Accessibility Survey

City of Downey Western Avenue - 7th Street to 5th Street

Date of Inspection
7/11/2017

Prepared By
Disability Access Consultants
(800) 743-7067

Curb Ramp : Parallel Curb Ramp Left Side Width

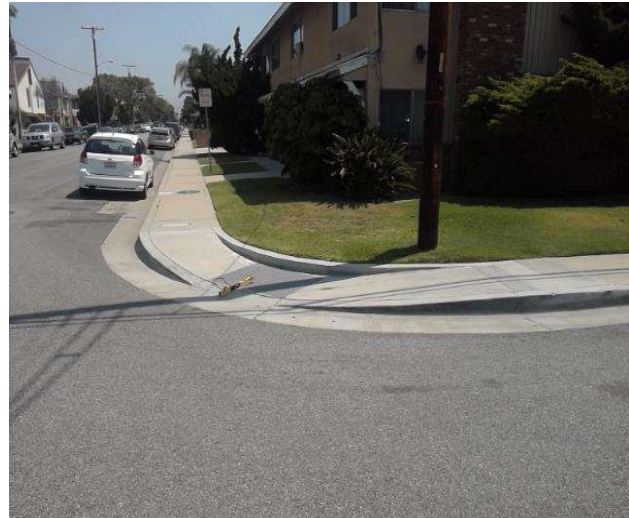
The width of the curb ramp is less than required.

On-Site Finding 42.00 inches

Provide a compliant curb ramp.

Recommendation At least 48.00 inches

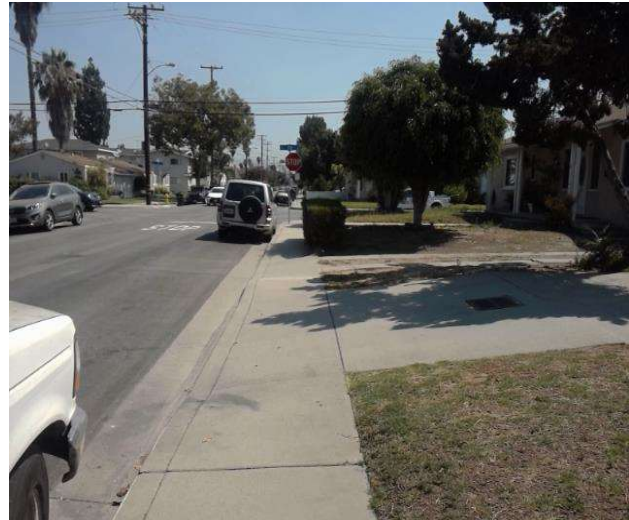
There are no detectable warnings where the pedestrian route crosses vehicular traffic.

On-Site Finding Not Found

Provide detectable warnings.

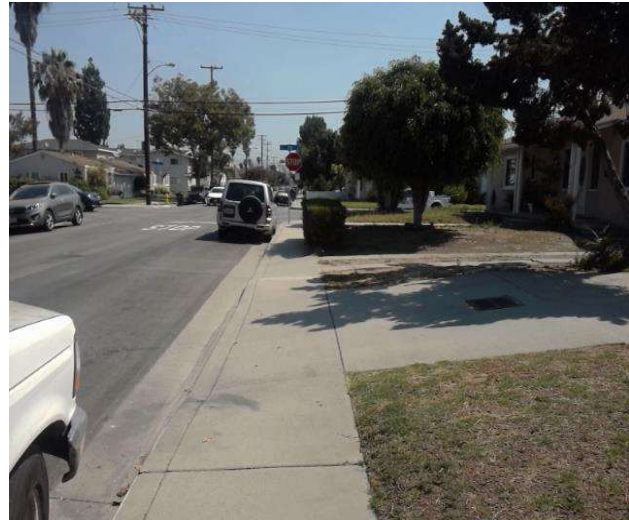
Cross slope at vehicular traffic is not compliant.

On-Site Finding 14.30 percent

Repave the surface to provide a compliant cross slope.

Change in Level South of Florence Avenue @ 33.950012836253, -118.129550367594

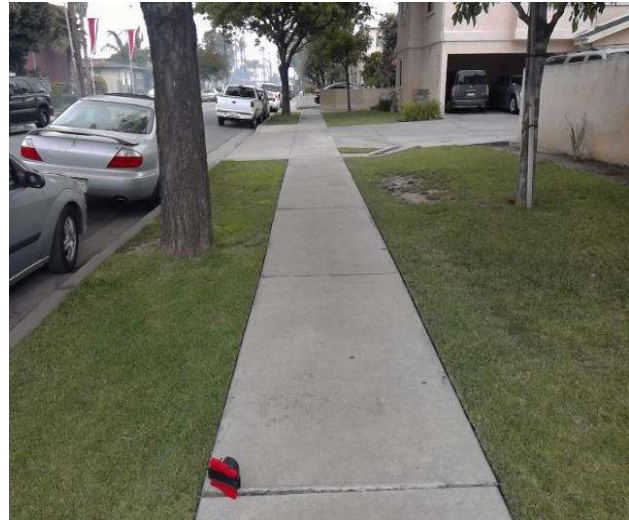
There is a change in elevation greater than recommended value.

On-Site Finding 0.87 inches

Ensure that the change in elevation is within the recommended value.

Change in Level North of 7th Street @ 33.951718250816, -118.128511011600

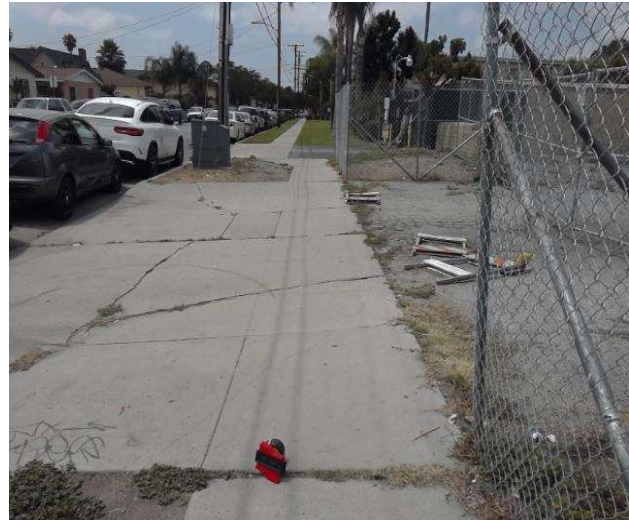
There is a change in elevation greater than recommended value.

On-Site Finding 0.75 inches

Ensure that the change in elevation is within the recommended value.

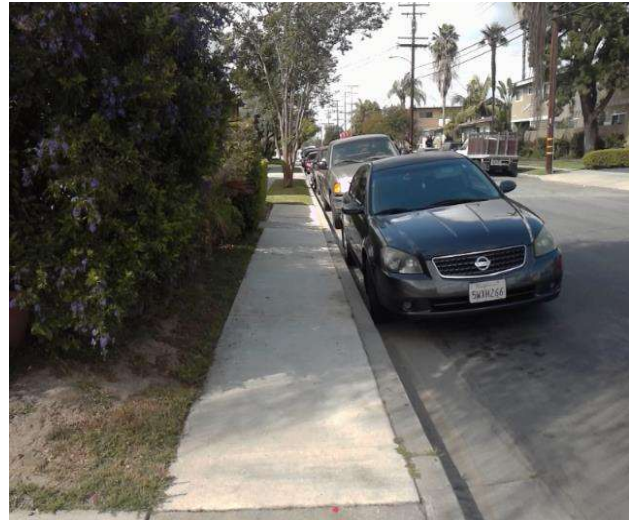
Sidewalk does not have enough width.

On-Site Finding 46.00 inches for 42.00 feet

Widen the sidewalk to the recommended value.
